Page No:	Requirement /Guideline:	Requested Change:	Why is Change required?	Document/s that must be changed
2.1 Vision				
13	Additional paragraph to be inserted into vision	Additional paragraph to insert: The PSP will also plan to increase community access to fresh food by providing appropriate edible food along the existing gas easements	To encourage, facilitate and reinforce urban agriculture in Cardinia.	Pakenham East PSP

Local Convenience Centre Pakenham East Precinct Structure Plan

Vpa Plan 3 - Future Urban Structure
 Pakenham East Precinct Urban Structure Plan

Attachment 1

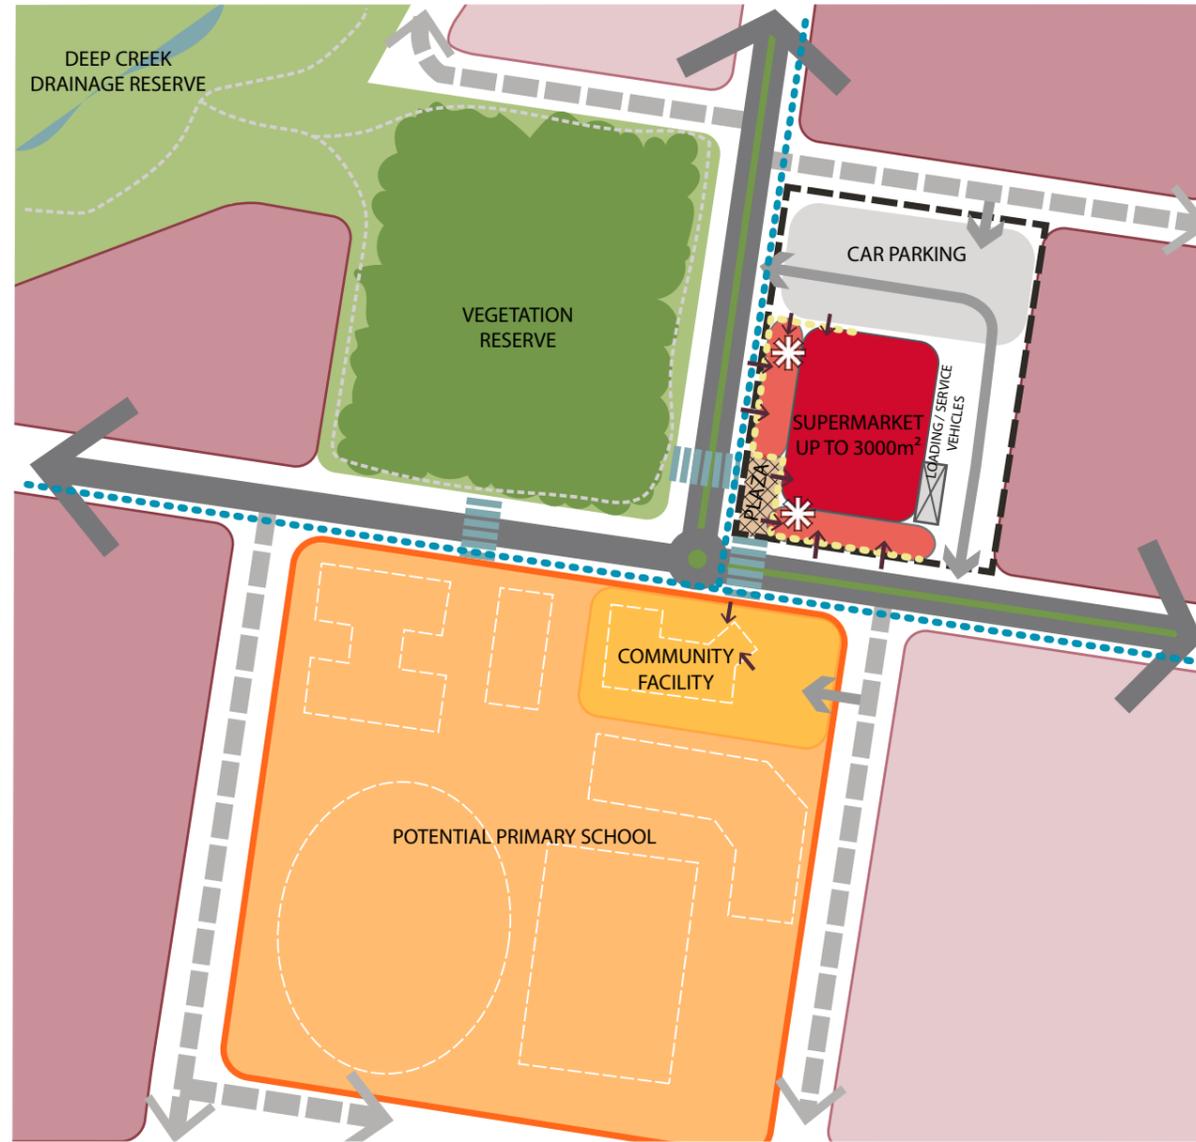
33	R27	<p>Modified wording required</p> <p>Create a town square and other civic spaces which provide the community with places for meeting, markets, performances, alfresco dining and lingering.</p> <p>The design of the town square is to:</p> <ul style="list-style-type: none"> • Provide appropriate street furniture and amenities within the town square (or civic space) to comply with the Cardinia Street Furniture Guidelines; requirements • Provide required circulation space around outdoor dining areas; • Provide built form interfaces to civic spaces that provide appropriate activation and connectivity. 	<p>Council is developing a Street Furniture Guideline. In the meantime all furniture will need to meet requirements as specified by our urban designers.</p>	Pakenham East PSP
33	New Requirement and New Figure	<p>New Requirement required</p> <p>The use and development of the local convenience centre must be generally in accordance with the Local Convenience Concept Plan, as shown in <i>Figure ? – Pakenham East Local Convenience Centre (LCC) Concept Plan</i> and must address the design principles outlined in <i>Appendix B: Local Convenience Centre (LCC) Principles</i>, and the <i>Urban Design Guidelines for Victoria, DELWP</i>.</p>	<p>A concept plan for the local convenience centre has been developed by Council and it would be beneficial for this plan to be shown in the Precinct Structure Plan to provide appropriate guidance on the development of the area. Please refer to Attachment 1</p>	Pakenham East PSP

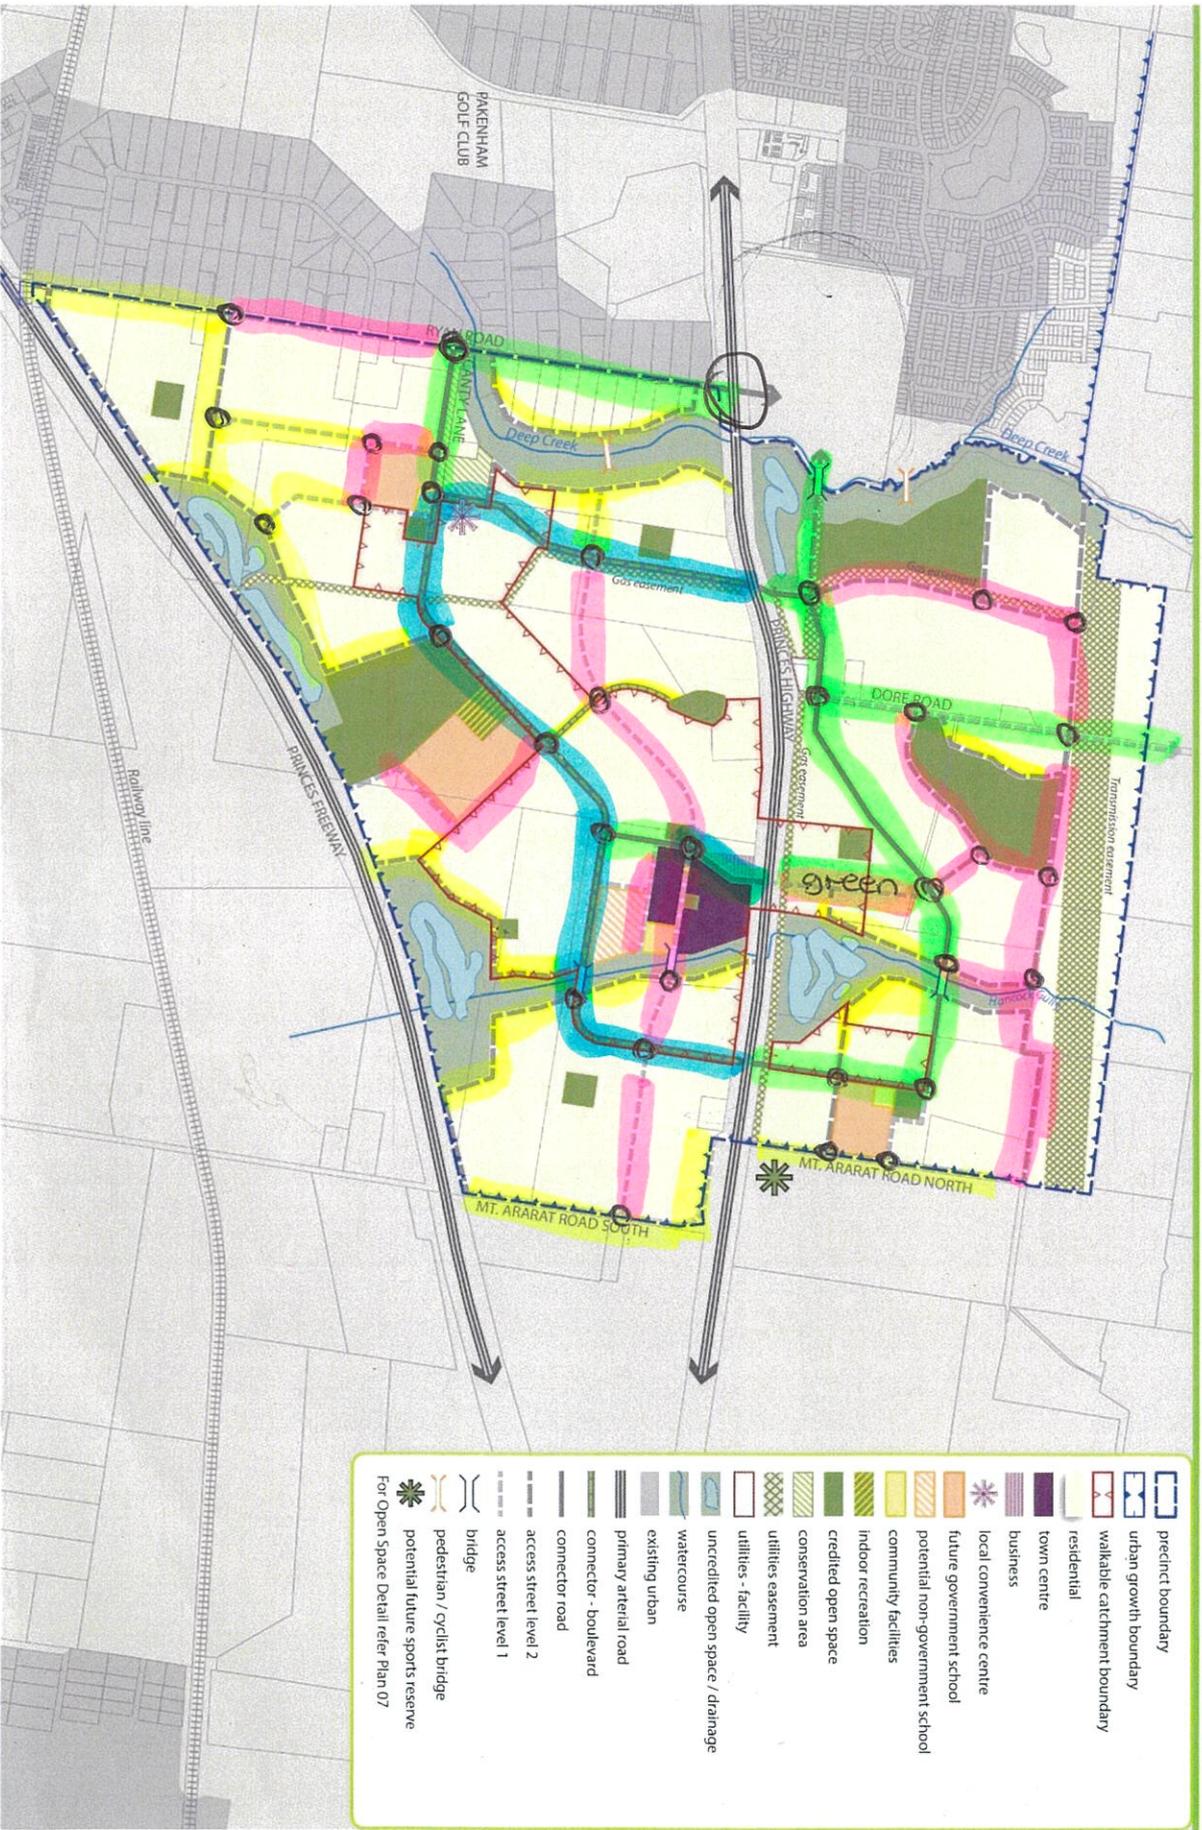
Page No:	Requirement /Guideline:	Requested Change:	Why is Change required?	Document/s that must be changed
		Plan 3 (Future Urban Structure) needs to be updated to make it clear which area is exempt from this requirement	Clarification required on what is identified as Conservation Area Local, as it's not shown on Plan 3 (Future Urban Structure). Is it the conservation area near Canty Lane or is it along Princes Highway or both? Proposed to delete wording to decrease confusion.	
44	R55	Modified wording required Development abutting the Deep Creek <u>Rural Conservation Zoned land and local conservation area near Canty Lane and conservation area near Princes Highway</u> must be in accordance with the corresponding relevant Interface Cross Section in <i>Appendix C: Road Cross Sections</i> , to the satisfaction of the Department of Environment, Land, Water and Planning , and the responsible authority and relevant.	Interface with all conservation areas need to be taken into consideration with appropriate corresponding interface road cross sections. Planning permits would be referred to relevant referral authorities as part of any future planning permits for consideration.	Pakenham East PSP

Page No:	Requirement /Guideline:	Requested Change:	Why is Change required?	Document/s that must be changed
			<ul style="list-style-type: none"> This scenario provides 264 kindergarten places, a shortfall of 128 four year old kinder places 	
16	Plan 4	Modified plan to show <ul style="list-style-type: none"> Parcel number and parcel identification number 13 is missing. 	Grammatical error	Pakenham East PSP
18	Plan 5	Modified plan to show: <ul style="list-style-type: none"> Demonstrate view lines from the open space hilltop LP01 looking north-east south and west. Demonstrate view lines from the open space hilltop LP07 north, east, south and west. Indicate Melbourne Water fish way And all Items requested as part of Plan 3	As per items raised in submission	Pakenham East PSP
36	Plan 6	Modified plan to show: <ul style="list-style-type: none"> The legend needs to be updated to reflect what is on the plan (for example local park in the legend is a different colour scheme to the plan Can the legend and plan be updated to explain the following: <ul style="list-style-type: none"> Pocket parks Neighbourhood Parks Sporting reserves Clarification required on what is identified as a Local Conservation Reserve (Requirement 59), as its not shown on Plan 6 (Open Space). Is it the conservation area near Canty Lane or is it the conservation area along Princes Highway or both? Plan 6 will require to be updated to provide greater clarity And all Items requested as part of Plan 3	As per items raised in submission	Pakenham East PSP
